# Access Compliance Report

## Public Rights-of-Way

Intersection ID: 21496	Main Street: SOUTH_BV	Cross Street: STARMOUNT_COVE_LN	Location: NE
ADA ID: 5B69DD645F89	Ramp Type: ParaDiag	Initial Pass/Fail: Fail	Overall Compliance: No
			Severity Score: 13.75

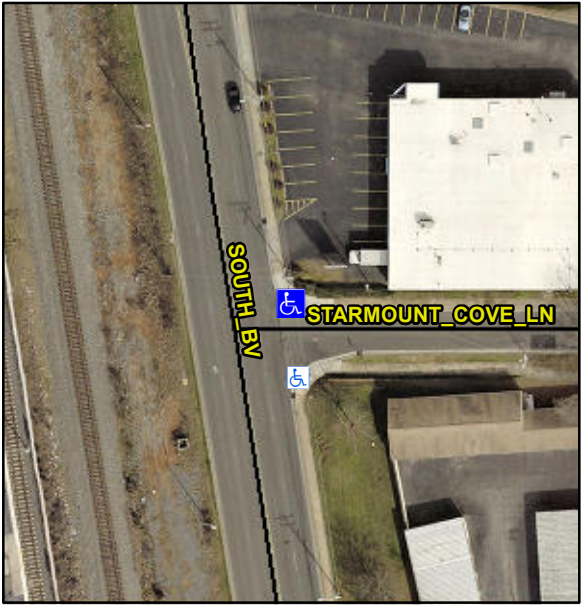
Codes/Mitigation Info/Possible Solution		Field Measurements/Component Compliance			
	Possible Solutions:				
	<b>Remove &amp; Replace Curb Ramp With Two New Directional Ramps or Equivalent.</b>				
	Surveyor Notes:				
	<b>N/A</b>				
	PROW/ADA:				
	<b>R304.3.2, R304.5.3</b>				
Street 1 Name	<b>SOUTH BV</b>				
Stop Condition-Street 1	<b>None</b>				
Street 2 Name	<b>STARMOUNT COVE LN</b>				
Stop Condition-Street 2	<b>StopSign</b>				
Total Cost:		\$	<b>3200.00</b>

Compliance	Description	Data	Compliance	Description	Data
N/A	Ramp Length LT (in)	70.0	N/A	Ramp Length RT (in)	37.0
Yes	Ramp Width LT (in)	60.0	Yes	Ramp Width RT (in)	58.0
No	Ramp Slope LT (%)	8.8	Yes	Ramp Slope RT (%)	7.6
No	Ramp XSlope LT (%)	2.1	Yes	Ramp XSlope RT (%)	1.1
N/A	Landing Length (in)	N/A	N/A	DWS Provided?	N/A
N/A	Landing Width (in)	N/A	N/A	DWS Contrast?	N/A
N/A	Landing Slope (%)	N/A	N/A	DWS Length (in)	N/A
N/A	Landing X Slope (%)	N/A	N/A	DWS Full Width?	N/A
N/A	Landing Curb? (Y/N)	N/A	N/A	DWS Offset (in)	N/A
N/A	Shared Landing?	N/A			
N/A	Gutter Ponding?	N/A	N/A	Gutter Slope (%)	N/A
N/A	Gutter Lip Ht (in)	N/A	N/A	Gutter X Slope (%)	N/A
N/A	Painted X Walk1?	No	N/A	Painted X Walk2?	No
	X Walk 1 Direction	To W		X Walk 2 Direction	To SE
N/A	X Walk 1 Width (in)	N/A	N/A	X Walk 2 Width (in)	N/A
	X Walk 1 Slope (%)	3.4		X Walk 2 Slope (%)	0.3
	X Walk 1 X Slope (%)	2.1		X Walk 2 X Slope (%)	4.2
N/A	Ramp inside XWalk1?	N/A	N/A	Ramp inside XWalk2?	N/A
